United States Patent and Trademark Office

APPLICATION NO.	FILING DATE	FIRST NAMED INVENTOR	ATTORNEY DOCKET NO.	CONFIRMATION NO.	
10/542,761	07/20/2005	Sario Buti	2247-116	9221	
6449 75	6449 7590 06/15/2006			EXAMINER	
ROTHWELL, FIGG, ERNST & MANBECK, P.C. 1425 K STREET, N.W. SUITE 800 WASHINGTON, DC 20005			TYLER, STEPHANIE E		
			ART UNIT	PAPER NUMBER	
			3754		
			DATE MAILED: 06/15/2006

Application No.	Applicant(s)			
	10/542,761	BUTI, SARIO			
Office Action Summary	Examiner	Art Unit			
	Stephanie E. Tyler	3754			
The MAILING DATE of this communication appears on the cover sheet with the correspondence address Period for Reply					
A SHORTENED STATUTORY PERIOD FOR REPLY IS SET TO EXPIRE 3 MONTH(S) OR THIRTY (30) DAYS, WHICHEVER IS LONGER, FROM THE MAILING DATE OF THIS COMMUNICATION. - Extensions of time may be available under the provisions of 37 CFR 1.136(a). In no event, however, may a reply be timely filed after SIX (6) MONTHS from the mailing date of this communication. - If NO period for reply is specified above, the maximum statutory period will apply and will expire SIX (6) MONTHS from the mailing date of this communication. - Failure to reply within the set or extended

Appendix A

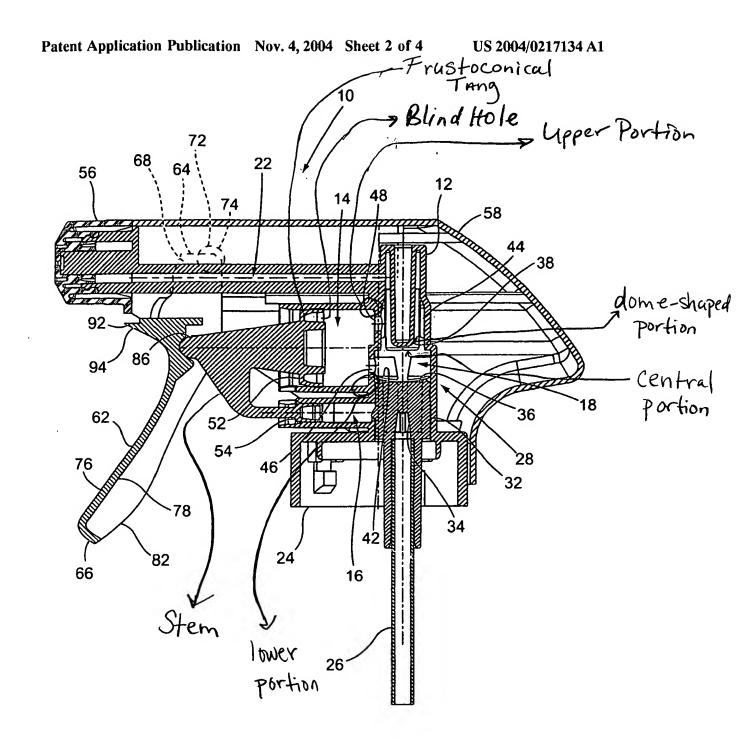
- 2. Claims 1-4 are rejected under 35 U.S.C. 102(e) as being anticipated by Foster et al. filed on April 16, 2003 (US2004/0217134).
- The Foster et al. reference discloses a sprayer device (10) with a triggeroperated pump (62) having a body (12) provided with a base that can be applied to the
 mouth of a liquid container and a delivery nozzle (56) wherefrom the liquid is sprayed, in
 said body (12) being formed a plunger chamber (14), an input duct (18) which puts the
 inside of the container into communication with the chamber (14) and an output duct

(22) which puts the chamber (12) into communication with the sprayer nozzle (15),
 through an input hole (46) and an output hole (48) respectively, formed in the rear wall
 of the chamber (14), a trigger lever (62) hinged to the sprayer body (12) and to the stem
 (see fig.2)¹ of a plunger (52) tightly acting in said chamber (14) defined in the sprayer
 body (12), spring means (pg.2, col.2,para.0027,lines 14-19) interposed between the

trigger (62) and the sprayer body (12), and a suction and delivery valve (38) disposed inside the chamber (14) of the sprayer body to generate a first one-way passage between the input duct (18) of the sprayer body and the chamber (14) and a second one-way passage between the chamber (14) and the output duct (22) of the sprayer body, characterized in that a housing seat (32,36) suited to integrally engage a central portion (fig. 2, Appendix A) of the valve (38) is disposed in the wall of the chamber (14), in a central position between the input hole (46) and the output hole (48).

Regarding claim 2 note in figure 2 wherein the suction and delivery valve (38) with respect to the central portion (Appendix A) engageable integrally in the valve-housing seat (32,36) formed in the body (12), having an upper portion (Appendix A) acting as a shutter for the output hole (48), and a lower portion (Appendix A) acting as a shutter for said input hole (46).

Regarding claim 3 note in figure 2 wherein the upper portion (Appendix A) of the valve (38) comprises a frustoconical tang (Appendix A) with a blind hole (Appendix A) tapered so as to generate a side wall thin enough to be deformed radially inward by the liquid pressure, the frustoconical tang (Appendix A) engaging in said output hole (48) formed in the sprayer body (12).

Regarding claim 4 note in figure 2 wherein the lower portion (Appendix A) comprises a substantially dome-shaped portion (Appendix A) connected to the valve body (28) by means of two flexible bridges (44), the dome-shaped portion (Appendix A) engaging in said input hole (46) formed in the sprayer body.

Appendix B

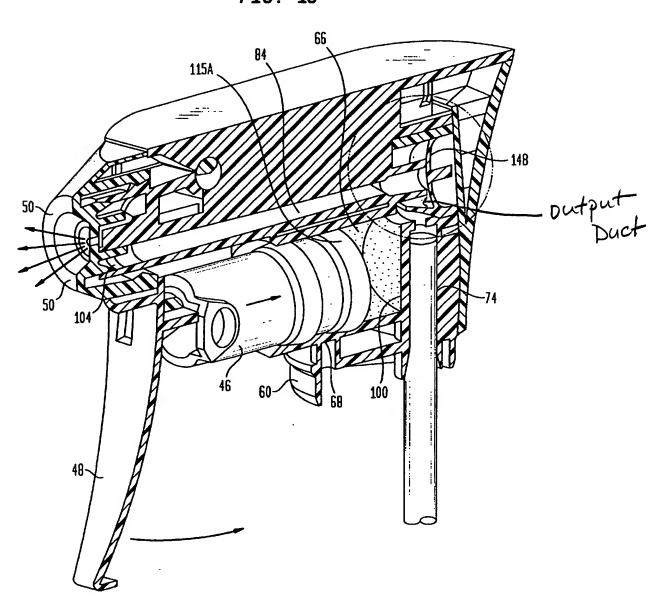
The Foster et al. reference discloses a sprayer device (10) with a triggeroperated pump (48) having a body (44) provided with a base that can be applied to the mouth of a liquid container and a delivery nozzle (50) wherefrom the liquid is sprayed, in said body (44) being formed a plunger chamber (70), an input duct (138) which puts the inside of the container into communication with the chamber (70) and an output duct (fig. 13)² which puts the chamber (70) into communication with the sprayer nozzle (50), through an input hole (72) and an output hole (82) respectively, formed in the rear wall of the chamber (70), a trigger lever (48) hinged to the sprayer body (44) and to the stem (112) of a plunger (46) tightly acting in said chamber (70) defined in the sprayer body (44), spring means (col. 16, line 17) interposed between the trigger (48) and the sprayer body (44), and a suction and delivery valve (52) disposed inside the chamber (70) of the sprayer body to generate a first one-way passage between the input duct (138) of the sprayer body and the chamber (70) and a second one-way passage between the chamber (70) and the output duct (fig. 13) of the sprayer body, characterized in that a housing seat (80) suited to integrally engage a central portion (fig. 10)³ of the valve (52) is disposed in the wall of the chamber (70), in a central position between the input hole (72) and the output hole (82).
